# UNITED STATES PATENT AND TRADEMARK OFFICE

APPLICATION NO.	FILING DATE	FIRST NAMED INVENTOR	ATTORNEY DOCKET NO.	CONFIRMATION NO.
10/733,160	12/10/2003	Robert L. Doubler	6683.99US01	5934
21917	7590	11/18/2005		
MCHALE & SLAVIN, P.A. 2855 PGA BLVD PALM BEACH GARDENS, FL 33410				
			EXAMINER FERGUSON, MICHAEL P	
			ART UNIT	PAPER NUMBER
			3679

<b>Office Action Summary</b>	<b>Application No.</b> 10/733,160	<b>Applicant(s)</b> DOUBLER ET AL.	
	<b>Examiner</b> Michael P. Ferguson	<b>Art Unit</b> 3679

## **DETAILED ACTION**

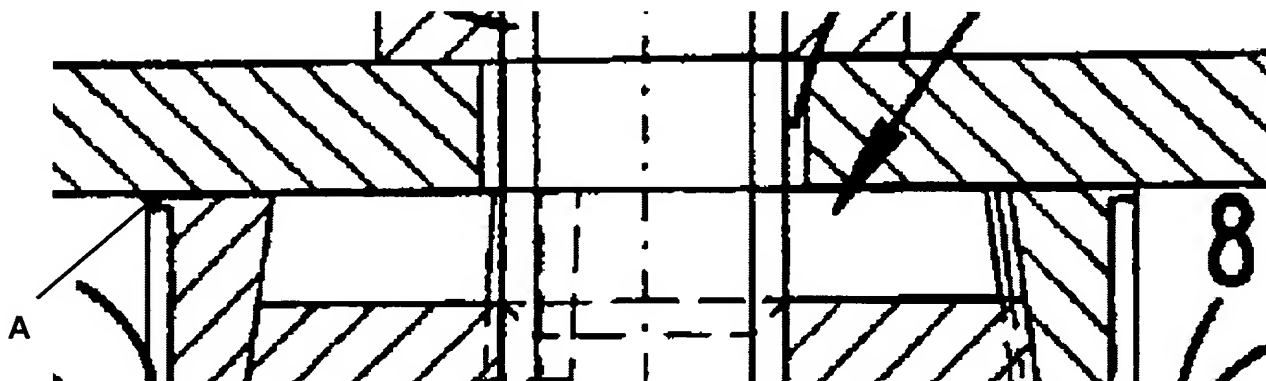
a body member **7** having an outer surface positioned about a central axis, the body member having a first end including a cavity, the cavity having an engaging surface, the engaging surface tapering inwardly from about the first end and extending toward a second end, the second end defining a clamping surface **A** (clamping against object **3**; Figure 6 reprinted below with annotations) adapted to engage the object;

a body member **7** defining a longitudinal axis and comprising a clamping end **A** (clamping against object **3**; Figure 6) adapted to engage an object **3** to be fastened, and an expandable portion **16** radially expandable relative to the longitudinal axis, the expandable portion having an inner surface defining a cavity in the body member and an outer surface;

As to claim 23, Krüger et al. disclose a fastener wherein the machinery component **2,4** comprises a portion (bolt **15**) adapted to support the object **3** to be fastened against the clamping end **A** (Figure 6).

As to claim 24, Krüger et al. disclose a fastener wherein both of the outer surface of the expander member **14** and the inner surface of the expandable portion **16** of the body member **7** has a portion at an angle from the longitudinal axis and adapted to remain in contact with the other one of the outer surface of the expander member and the inner surface of the expandable portion of the body member during the longitudinal advancement of the expander member (Figure 6).

As to claim 25, Krüger et al. disclose a fastener wherein the expandable portion **16** of the body member **7** has a portion at an angle from the longitudinal axis and adapted to remain in contact with the gripping surface **4** during the radial expansion of the expandable portion of the body member (Figure 6).

As to claim 26, Krüger et al. disclose a fastener wherein the outer surface of the expander member **14** and the inner surface of the expandable portion **16** of the body member **7** form a self-locking taper (Figures 2 and 6).

Examiner disagrees. As to claim 1, Krüger et al. disclose a fastener system wherein the body member **7** outer surface and the gripping surface **4** are configured and positionable relative to each other to from a compressive contact with each other to linearly shift relative to each other under the compressive contact to cause an increased compression between the clamping surface **A** and the object **3** when the body member is circumferentially expanded from an unloaded state (Figures 2 and 6).
